Decurl on Diameter - eCon Sheeter

TIP MWU-1011

Machine Model for Improvement: eCon Sheeters

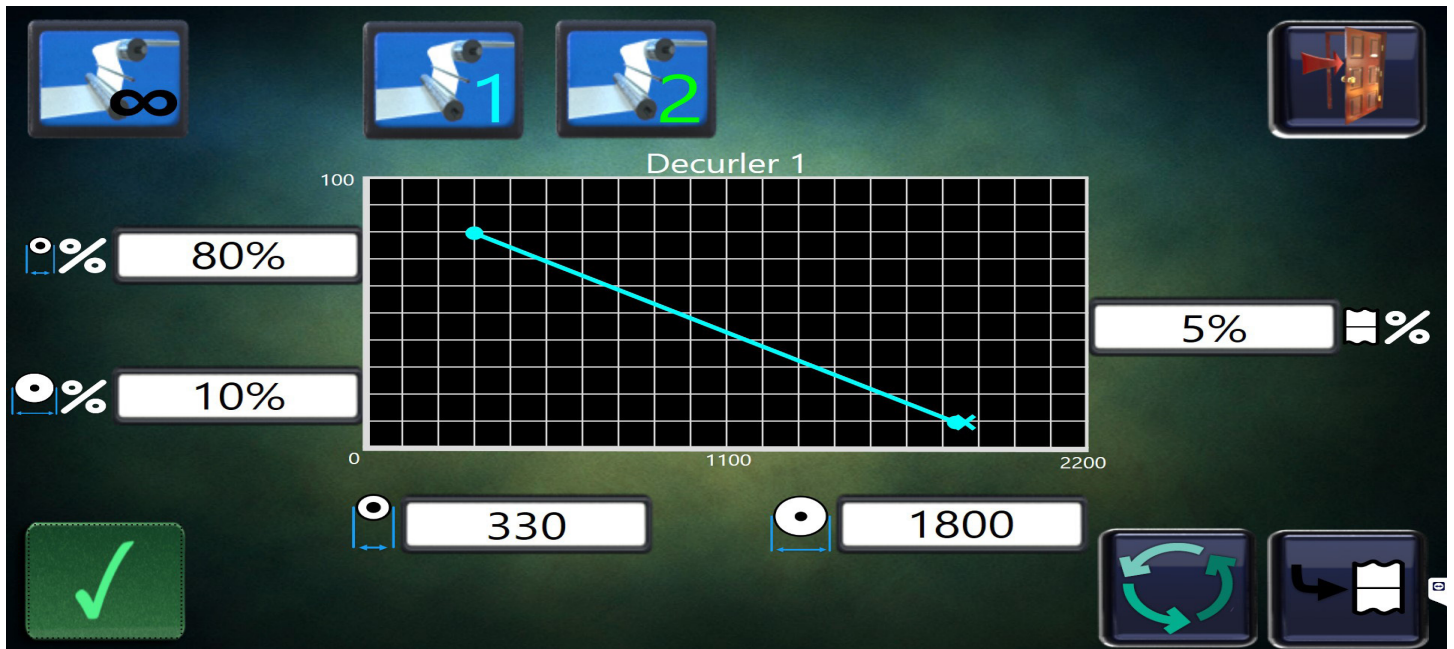
The current eCon Sheeters do not have an option for an auto decurl function. The operator must go to the main operator station at the shingling belts and increase decurl every few minutes to keep board flat and prevent jams. This manual operation requires significant operator time and consequently a decreasing efficiency. Additionally, the manual decurl adjustment is subject to errors and malfunctions due to too much or too little decurl. This influences the product quality in a negative way.

This TIP provides an automatic adjustment of the decurl according to the reel diameter during the production. The auto decurl function can be configured in the HMI (e.g. start/stop diameters and position).
